June 30, 2017 (revised August 17, 2017)

Re: Martin Marietta's Parsons Mine Substitute Water Supply Plan (WDID 0302583, Plan ID 5822)
DRMS File No. M-2009-082 (WDID 0303045)
Sections 25 and 36, T6N, R67W, 6th P.M., and Sections 30 and 31, T6N, R66W, 6th P.M.
Water Division 1, Water District 3, Weld County

Approval Period: June 1, 2017 through May 31, 2018

Figure 1
Martin Marietta
Parsons Mine
Mining Phases

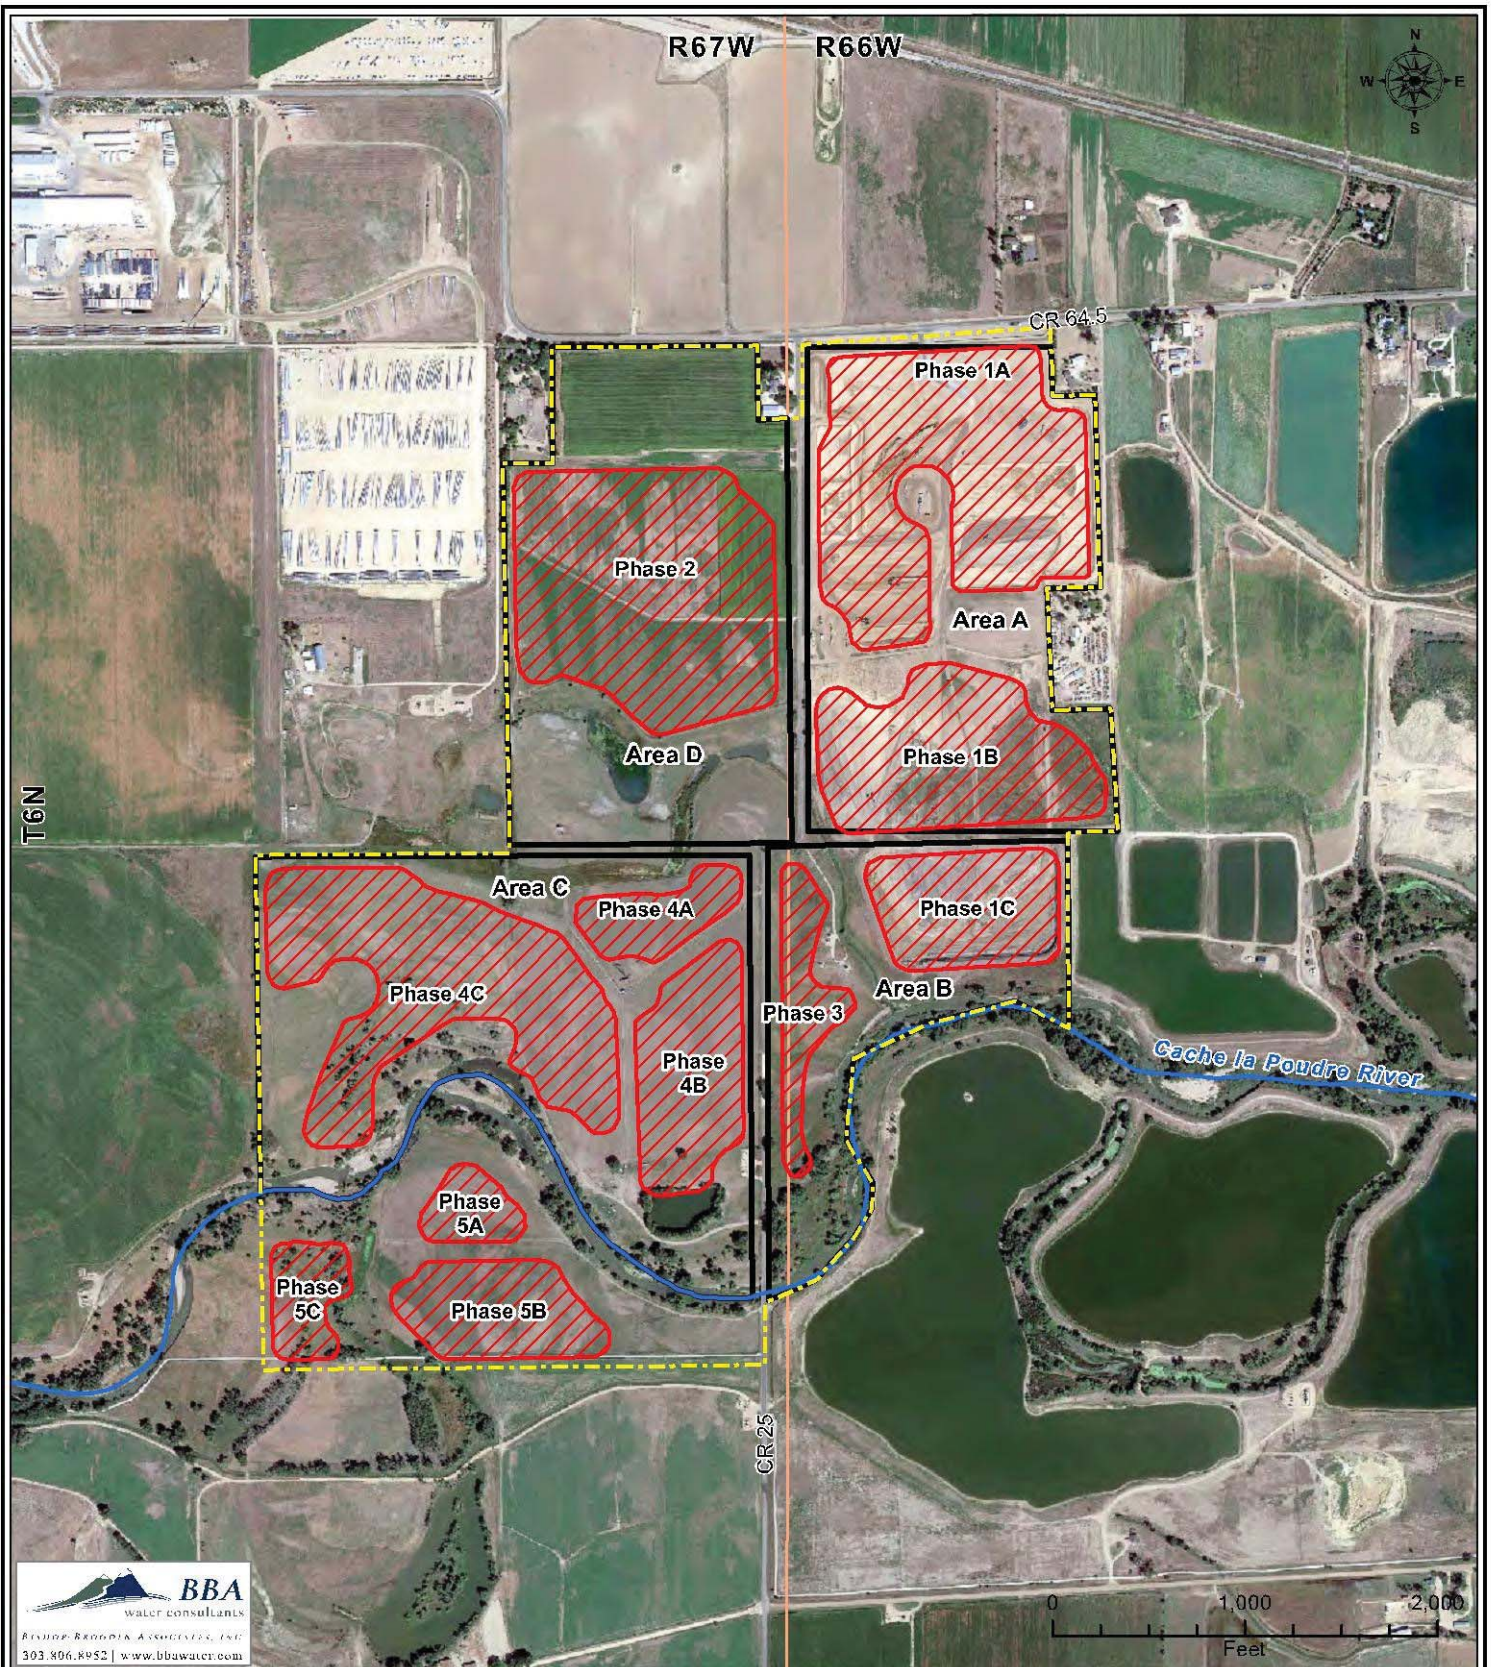
As shown in the attached Figure 1, Phase 1A and Phase 1B are located within Area A, while Phase 1C is located within Area B. The total lagged depletions for the Parsons Mine site were determined to be 66.07 acre-feet for this plan period. This amount includes lagged depletions resulting from past consumptive use at the site that are projected to impact the river during this plan period. A monthly breakdown of lagged depletions, both by area and in total, is shown in the attached Table 1.

Figure 2
Martin Marietta
Parsons Mine
Whitney Ditch
Dry-Up Area

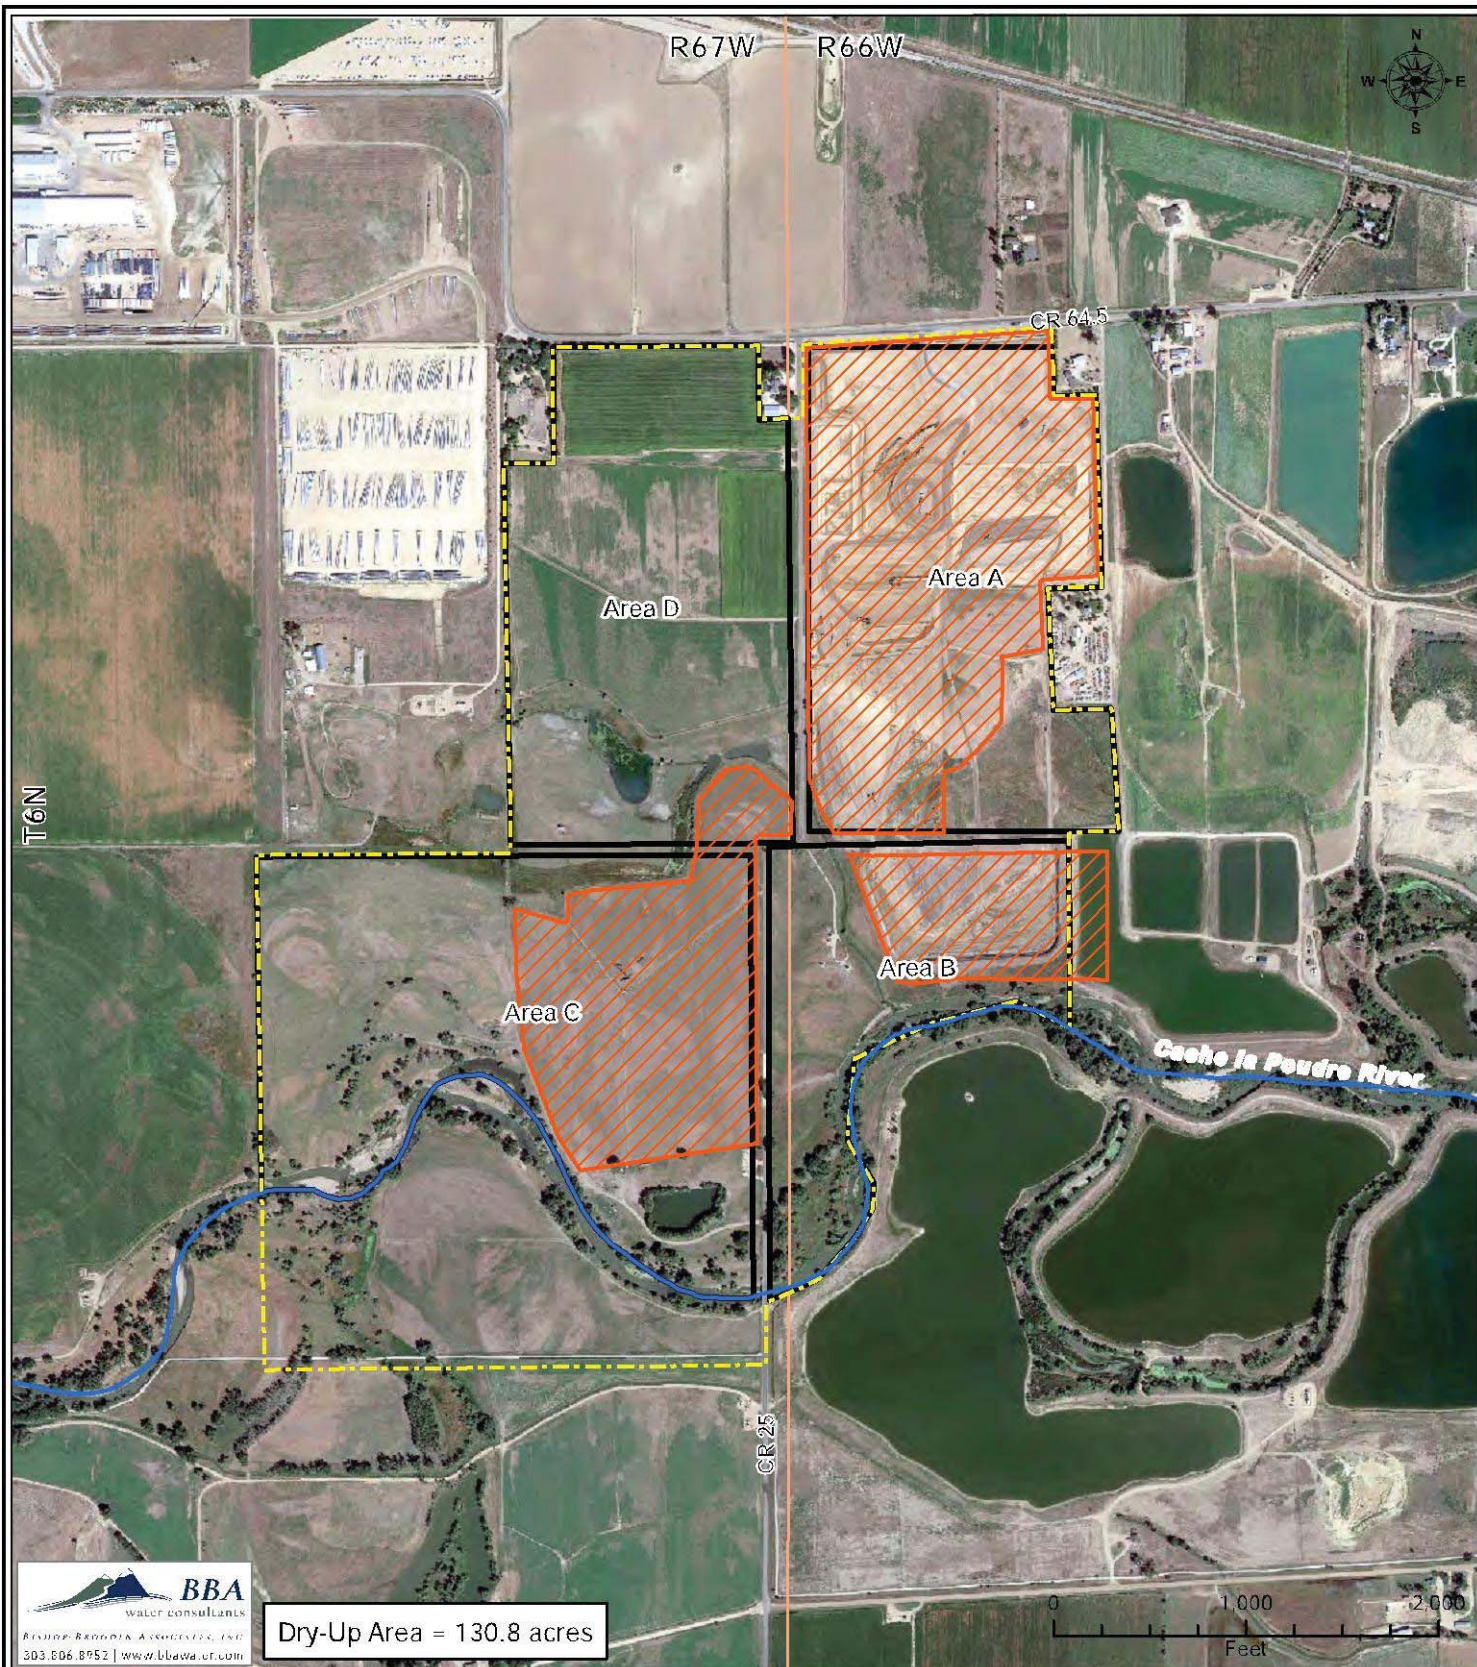
20. Approval of this SWSP is contingent on the dry-up of the 130.8-acre portion of the Applicant's property as shown on the attached Figure 2. The lands to be dried up shall be monumented by the Applicant to the satisfaction of the water commissioner. In accordance with the attached *Administration Protocol - Dry-Up of Irrigated Land* the Applicant shall provide an affidavit to the water commissioner and division engineer that confirms dry-up during the 2017 irrigation season **by October 31, 2017**. A GIS shapefile outlining the dry-up must accompany the affidavit and be emailed to DNR_Div1Accounting@state.co.us. The
